SECTION 00 91 15

ADDENDUM NUMBER 6

- 1.01 DATE: JANUARY 22, 2021**
- 1.02 PROJECT: ELMORE SPORTS MEDICINE RENOVATIONS**
- 1.03 PROJECT NUMBER: DCM NO. 2020452; PSCA NO. 2018**
- 1.04 OWNER: ALABAMA A&M UNIVERSITY**
- 1.05 ARCHITECT: NOLA | VAN PEURSEM ARCHITECTS, PC**

AD6-A5.1-02

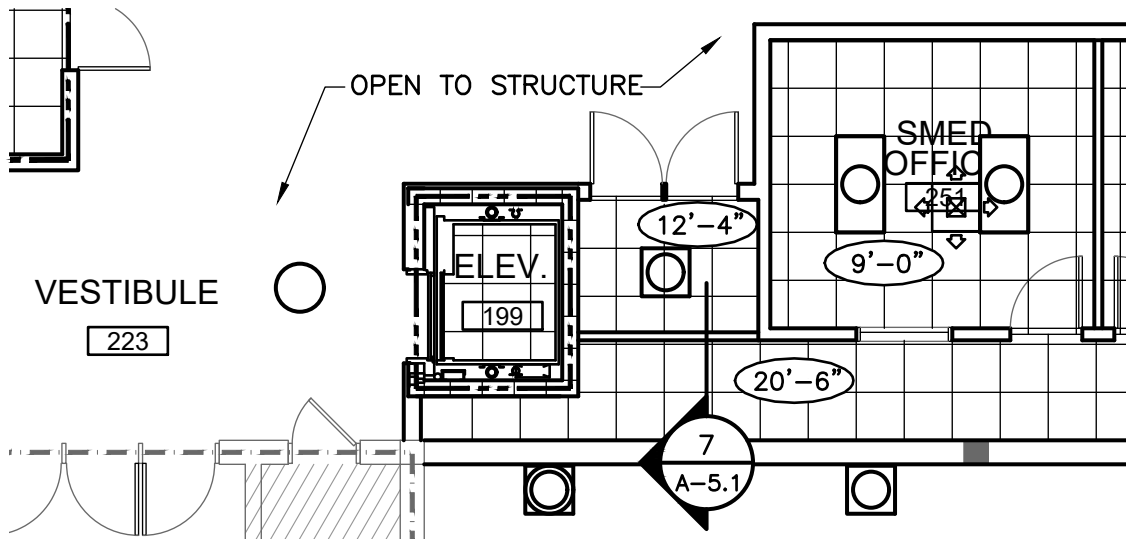
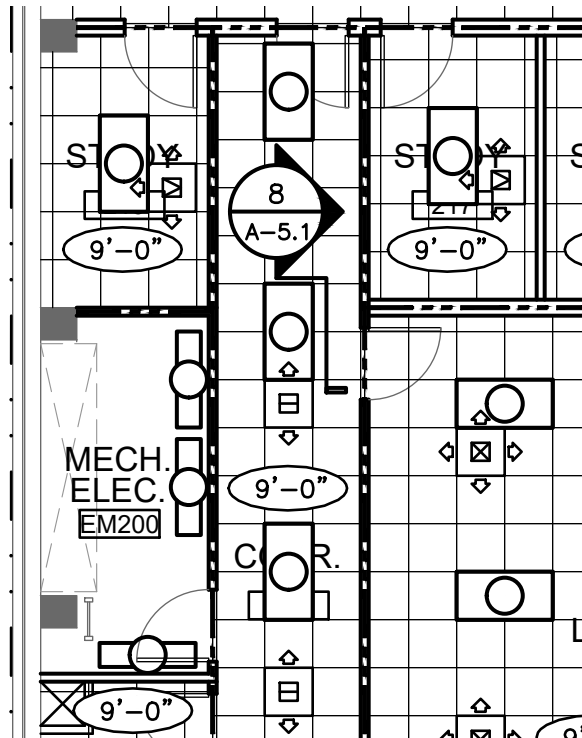
- A. Door Schedule:
1. Add cased opening 256.1 Training to Mechanical Mezzanine – painted Hollow Metal Type HM-1, Head Detail 1, Jamb Detail 3, Sill Detail 5. Note Cased opening frame dose not require a stop.
 2. Door 256:
 - a. Change size of door to be 3'x7'x1-3/4".
 - b. Add Head Detail 1, Jamb Detail 3, and Sill Detail 5.
- B. Detail 4/A-5.1: remove section markers referencing sheet A-5.4 on HM5 and HM6.
- C. Add Soffit Detail 7/A-5.1 per attachment AD6-A5.1-01.
- D. Revise 6/A-5.1 Partial RCP Mezzanine around new elevator per attachment AD6-A5.1-01.
- E. Add above ceiling rated wall/soffit detail 8/A-5.1 and tag to partial plan per attachment AD6-A5.1-02.

AD6-A6.1-01

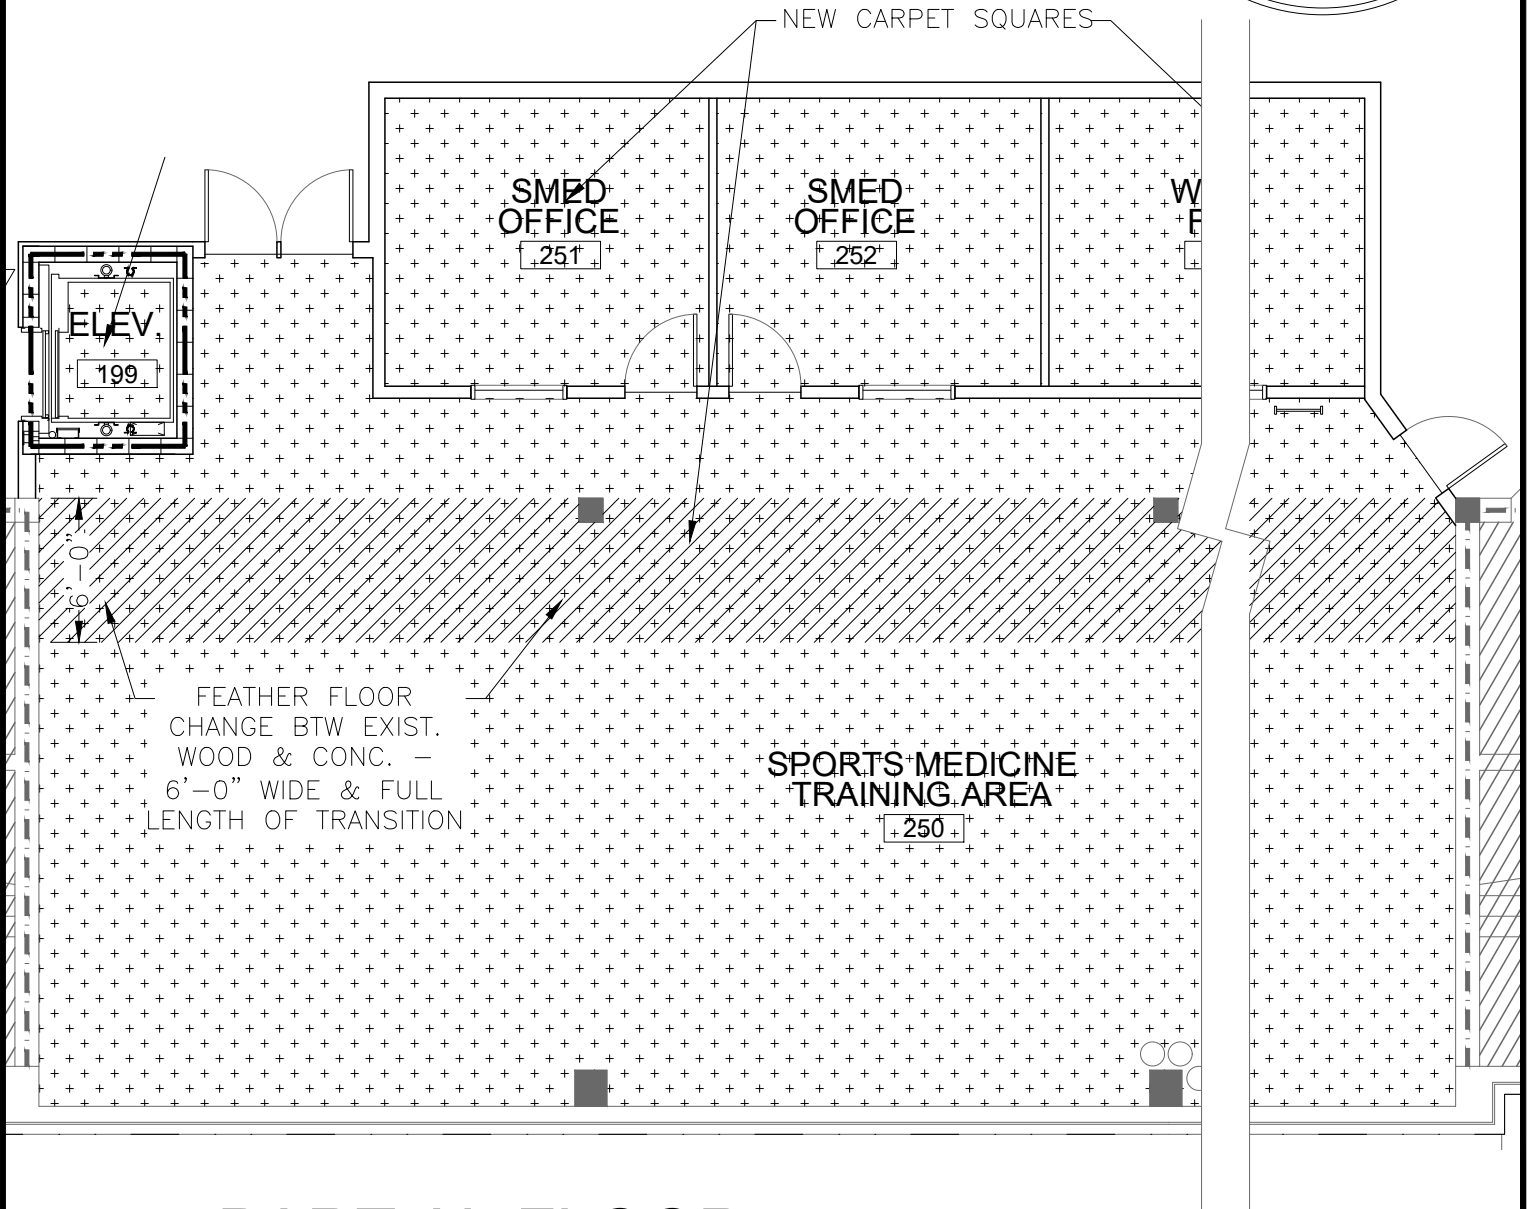
- A. Detail 1/A-6.1 Enlarged Restroom Plan: Change accessory A7 located behind door RR-01 to be accessory A4.
- B. Add Typical Restroom Note 5 to read as follows, "5. Provide for 60 sq. ft. of new floor tile and grout to match existing restroom floors."
- C. Add Typical Restroom Note 6 to read as follows, "6. Provide spacer behind A7 to sit flush with tile wainscot."
- D. Add feathering of floor transition from existing wood floor to existing concrete floor at Sports Medicine Training Area250 per attachment AD6-A6.1-01.

AD6-S1.0-01

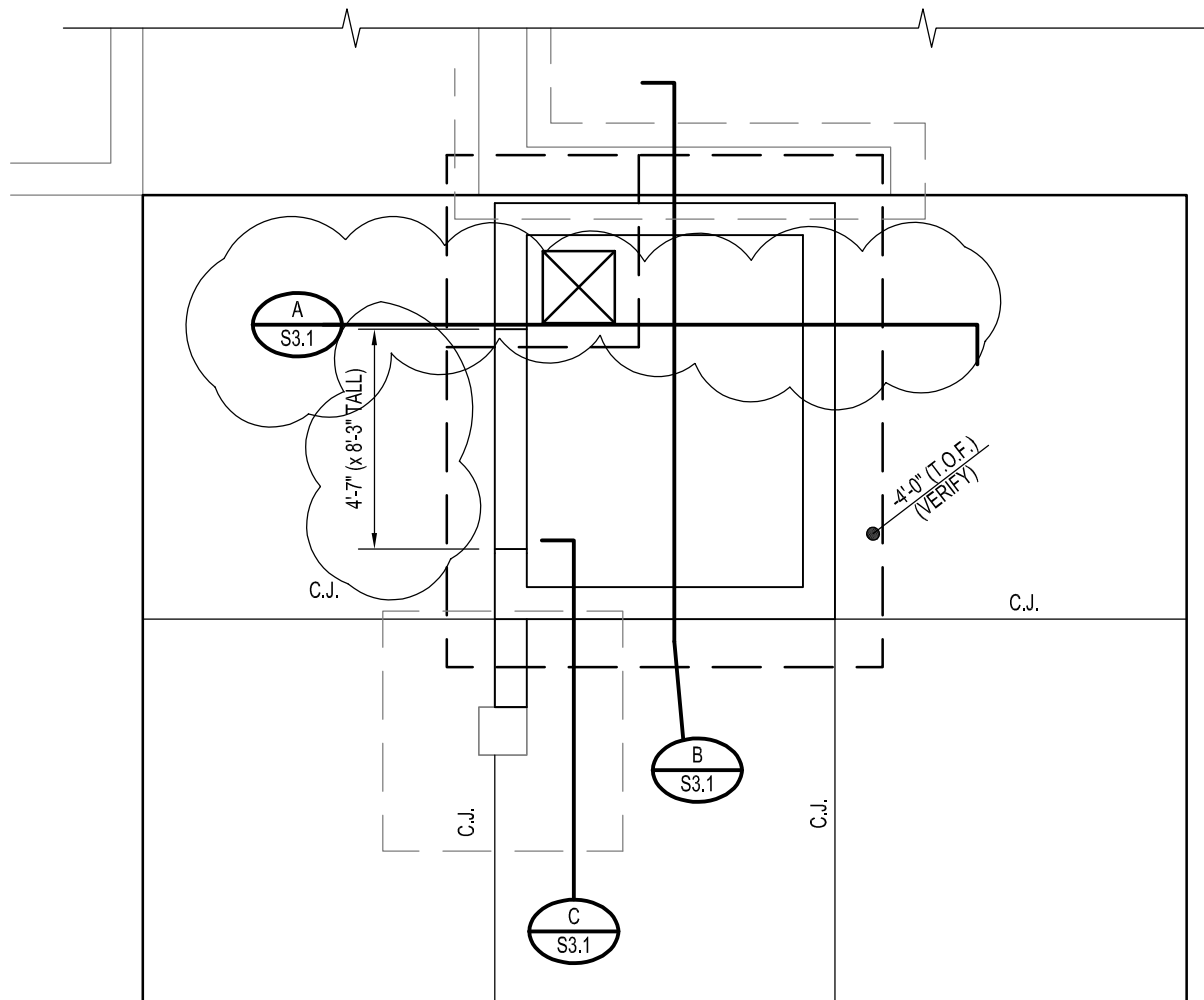
- A. See attachment AD6-S1.0-01 for the following revisions:
1. Added elevator door rough opening dimension.

2. Moved the location of the pump to the corner of the shaft.
3. Changed the top-of-footing elevation to -(4'-0").

AD6-S1.1-01

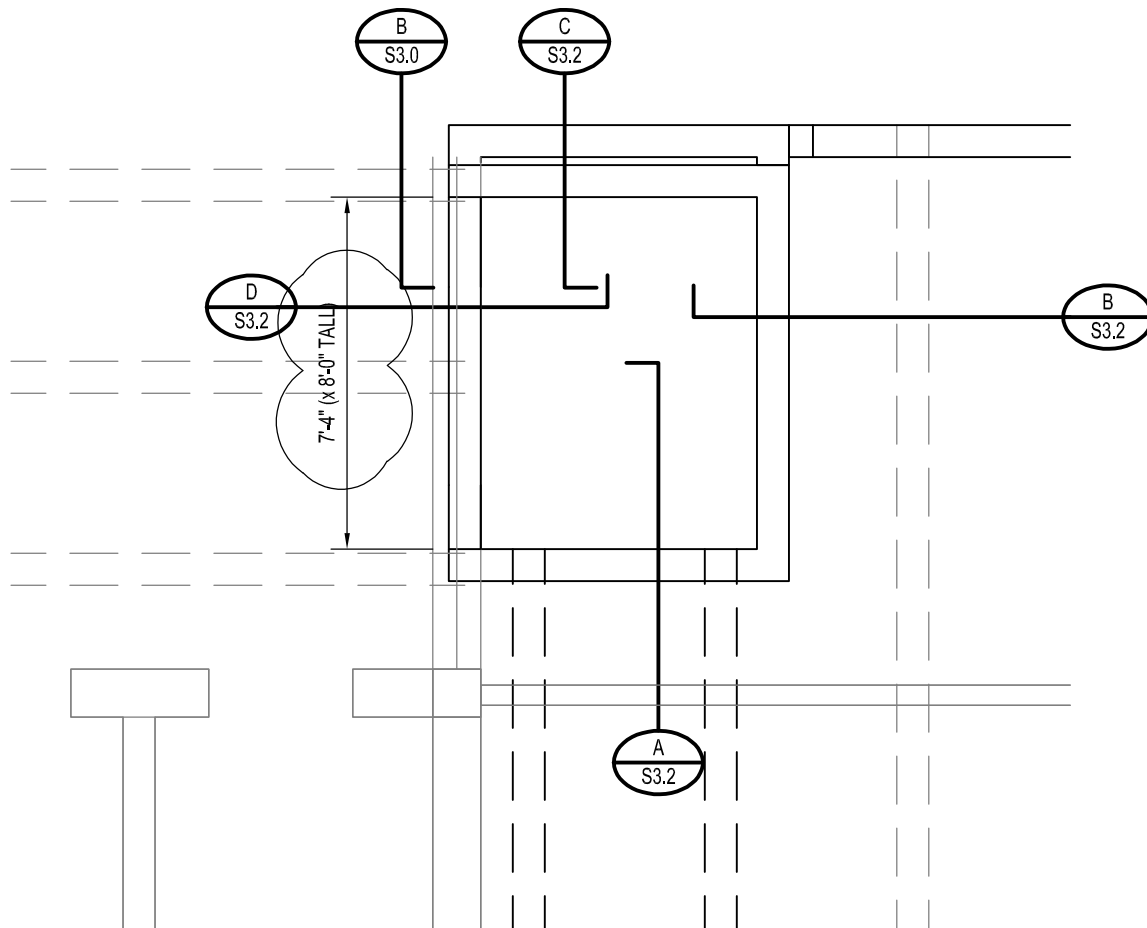
- A. Add elevator door rough opening dimension per attachment AD6-S1.1-01.

AD6-S1.2-01

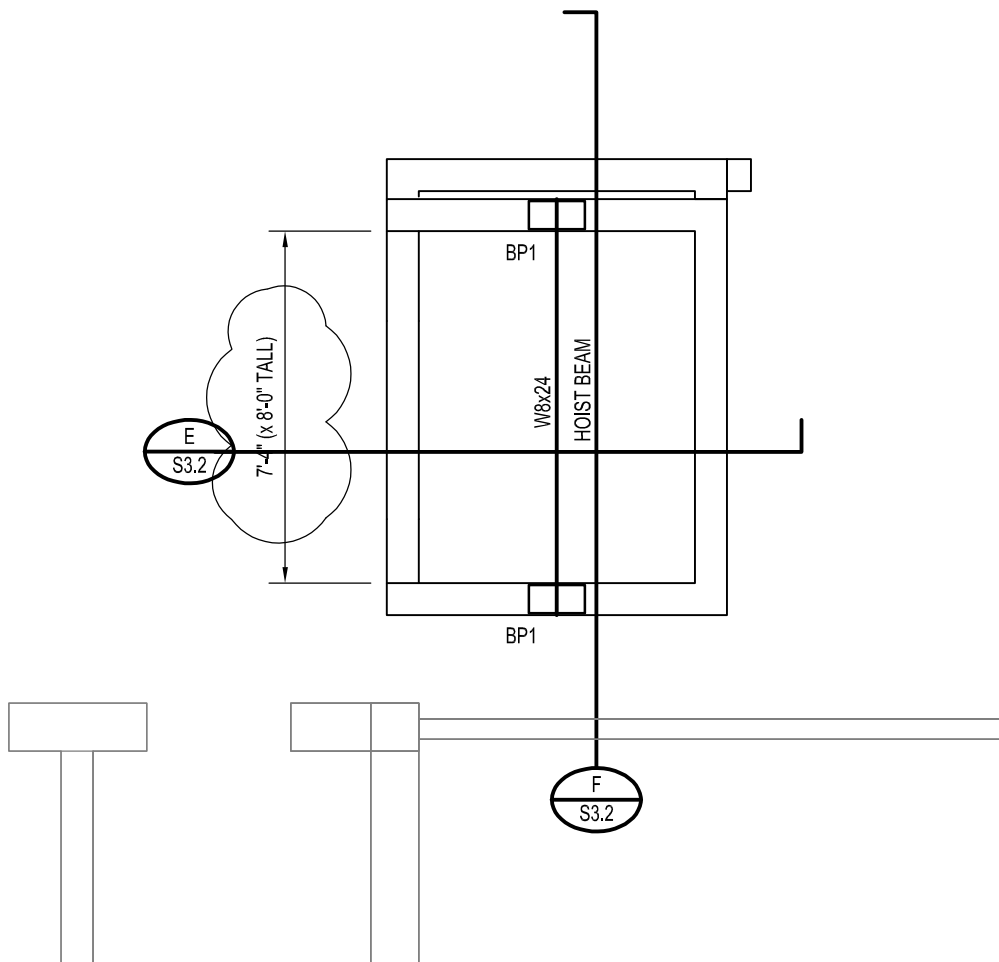
- A. Add elevator door rough opening dimension per attachment AD6-S1.2-01.

AD6-S3.1-01

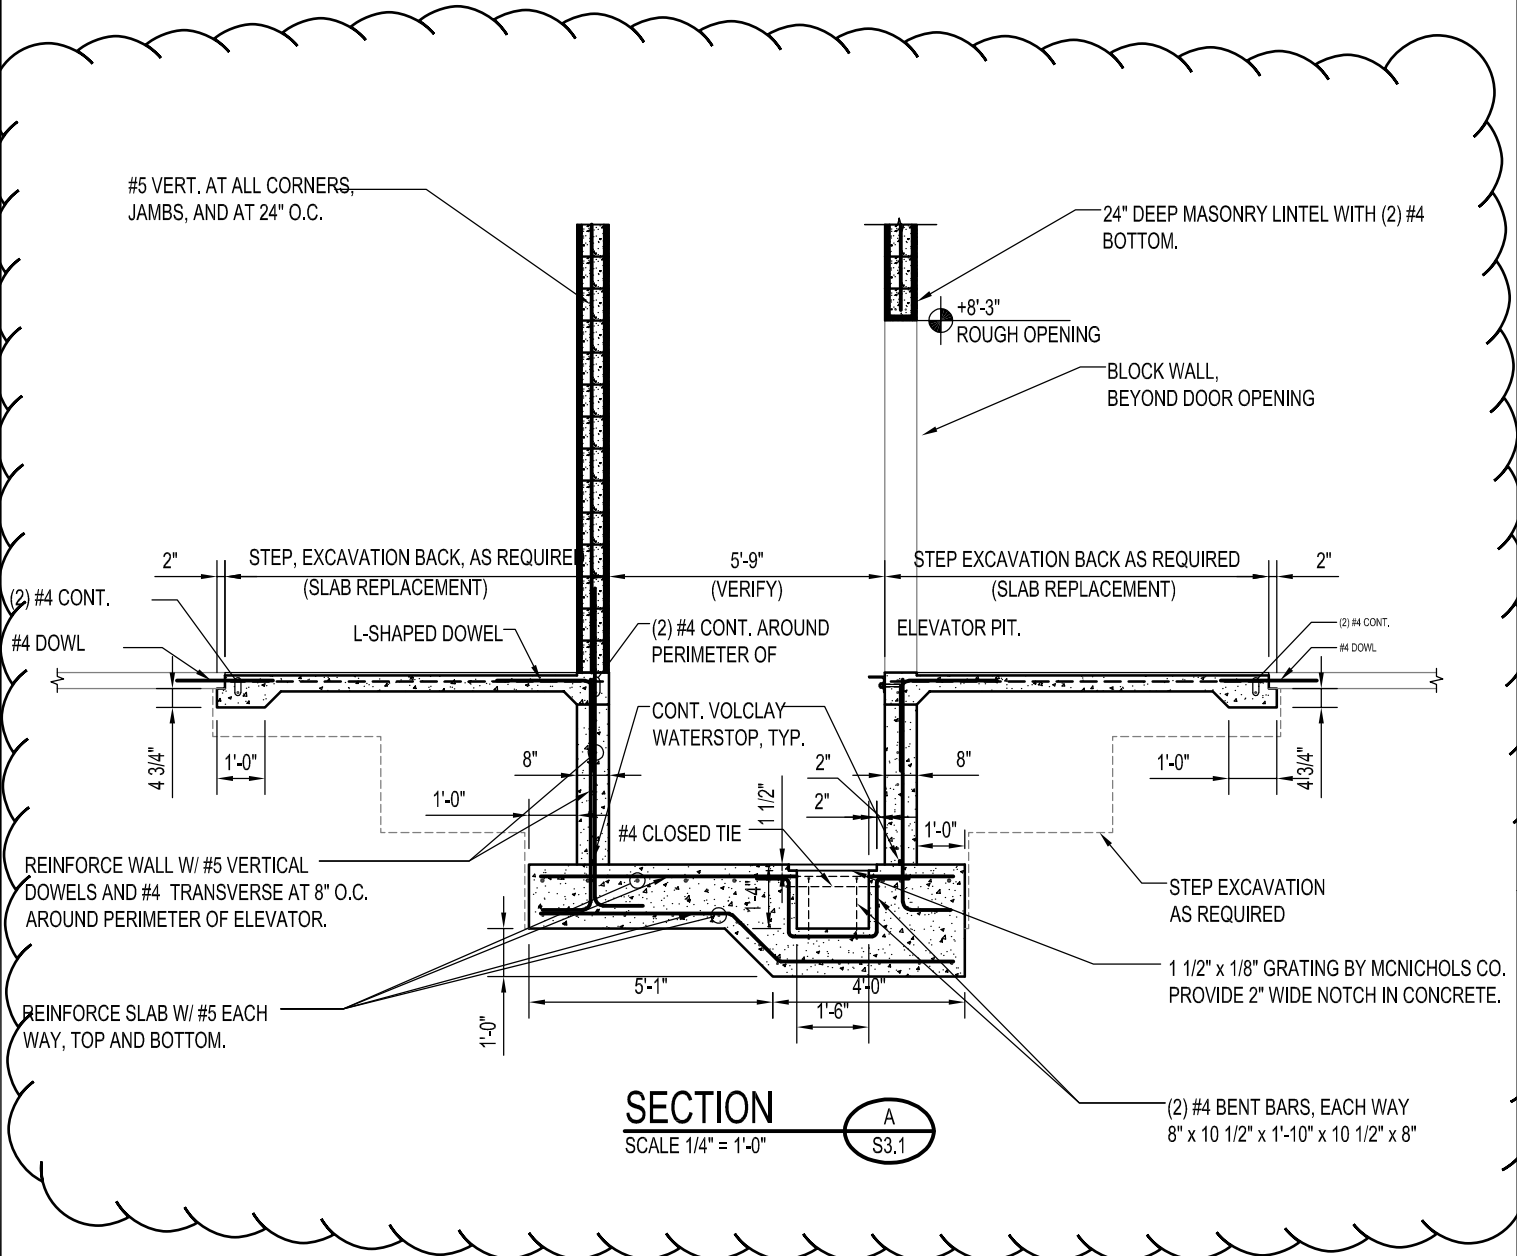
- A. Replace Section A/S3.1 in its entirety per attachment AD6-S3.1-01.

AD6-S3.2-01

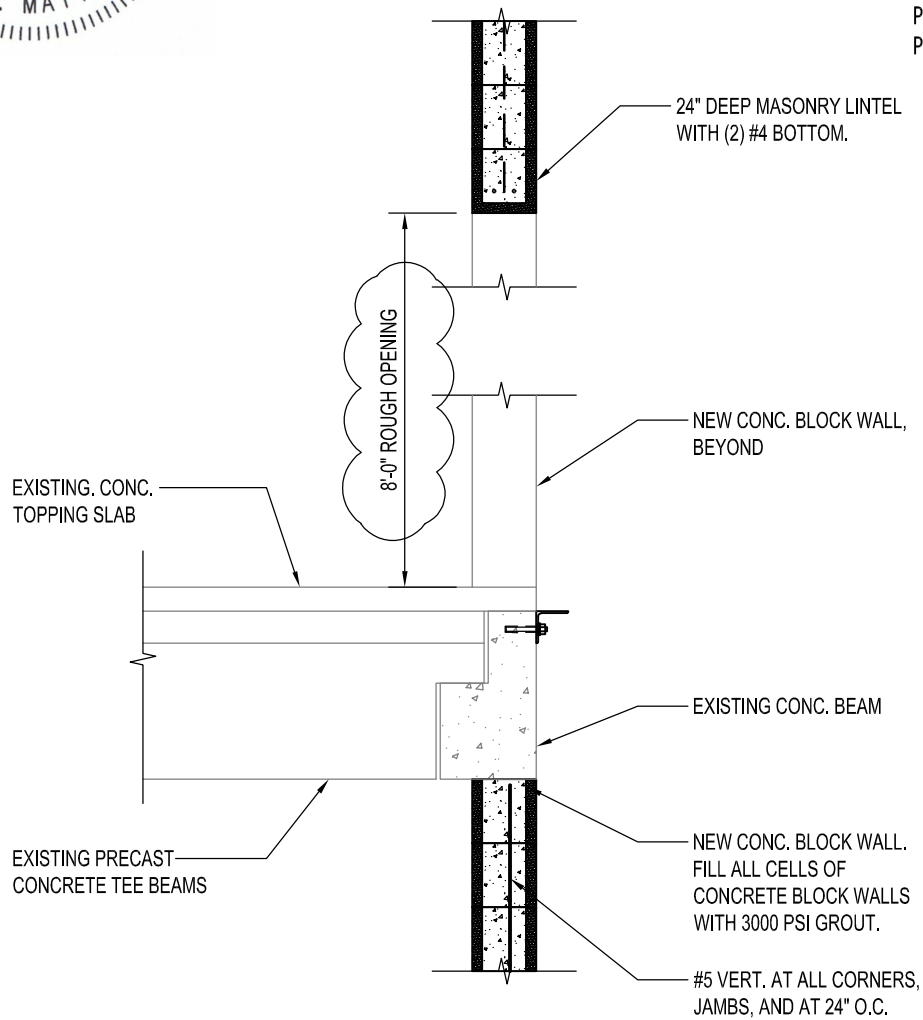
- A. Section D/S3.2: Add elevator door rough opening dimension per attachment AD6-S3.2-01.
- B. Section E/S3.2: Revise section per attachment AD6-S3.2-02.
